STAFF REVIEW COMMITTEE
Minor Development Review
DRAFT Findings of Fact
Review Date: October 16, 2020

Project Name: Garage Addition
Project Location: 608 Harpswell Road
Tax Map: Map 34, Lot 33 RP1
Zoning District: SPO, FPO, RPSMO
Overlay: 20-048
Case Number:
Applicant & Owner: Fernando Stelser
608 Harpswell Road
Brunswick, ME 04011

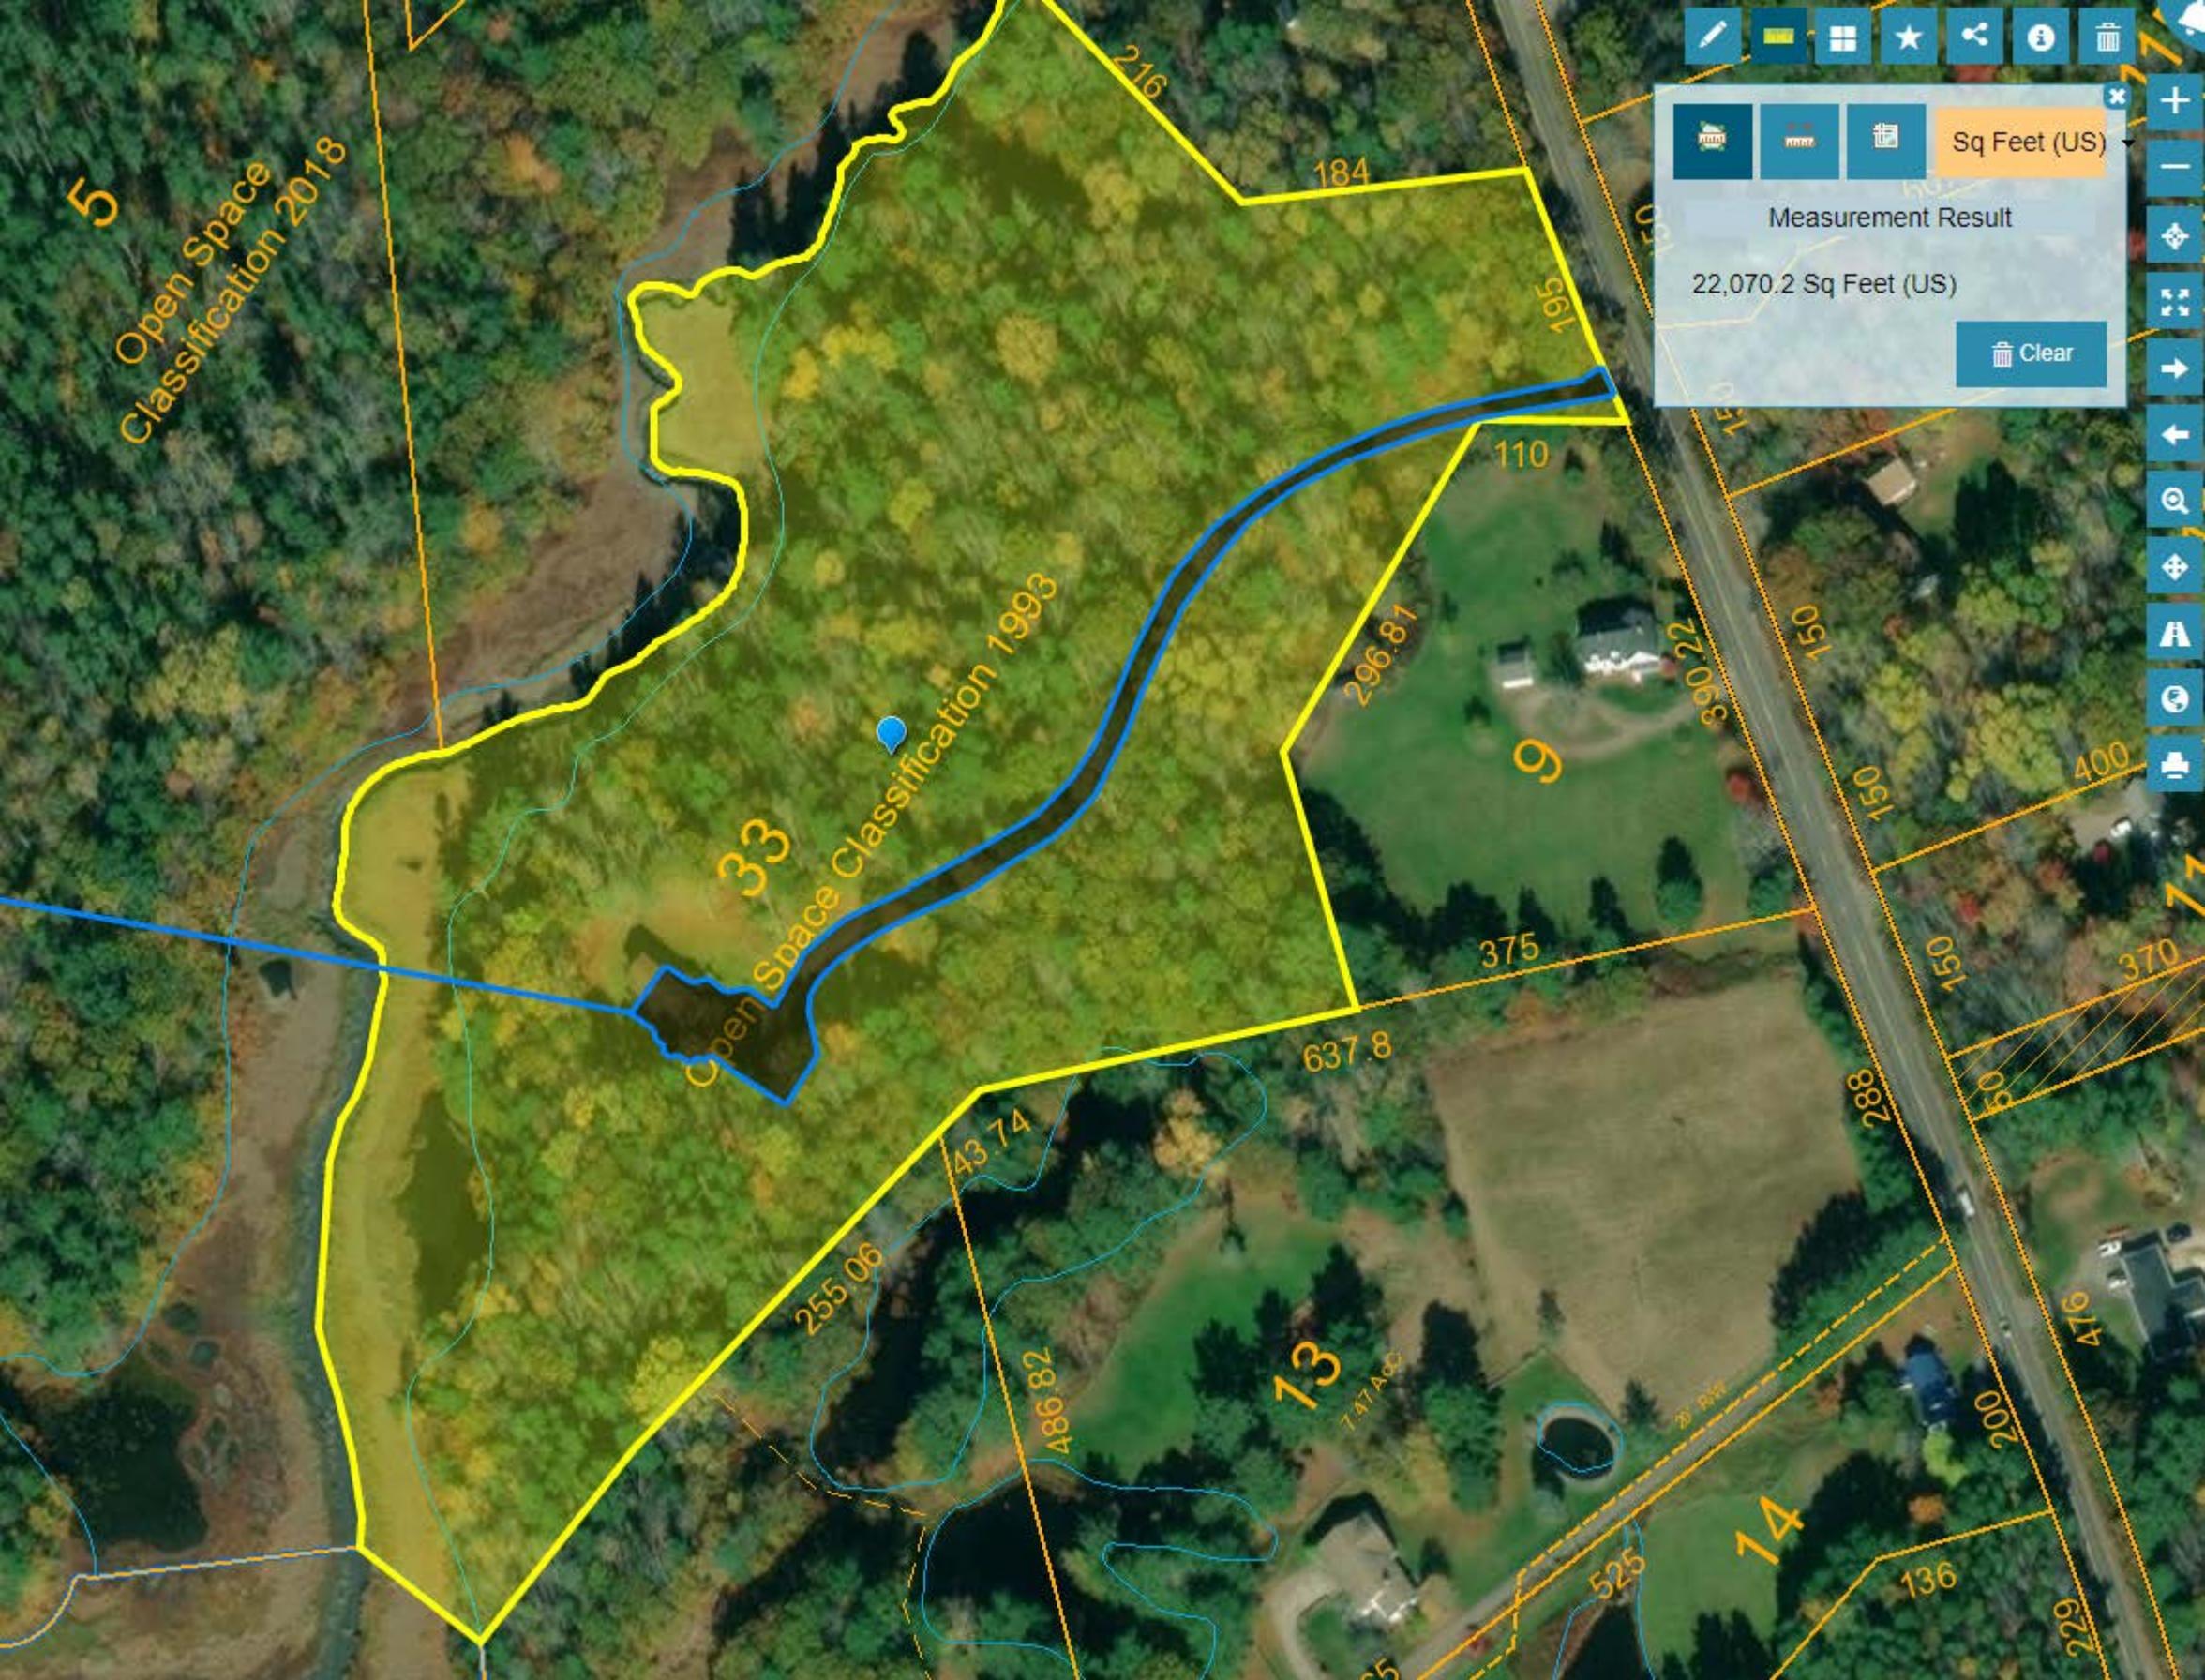
Total Acreage 12 = 522720sqft
Current non vegetated area = 22070sqft
New Non vegetated area 25603sqft
250 ft shoreland area =314845sqft

New Garage addition 27x27 = 729sqft
New Revised Deck size 18' X 19'6"= 351sqft
New front door area 136sqft
Minus Front door deck removal - 290sqft
Current ft print 3091sq ft
Allowed expansion 927sqft
Proposed expansion 926sqft
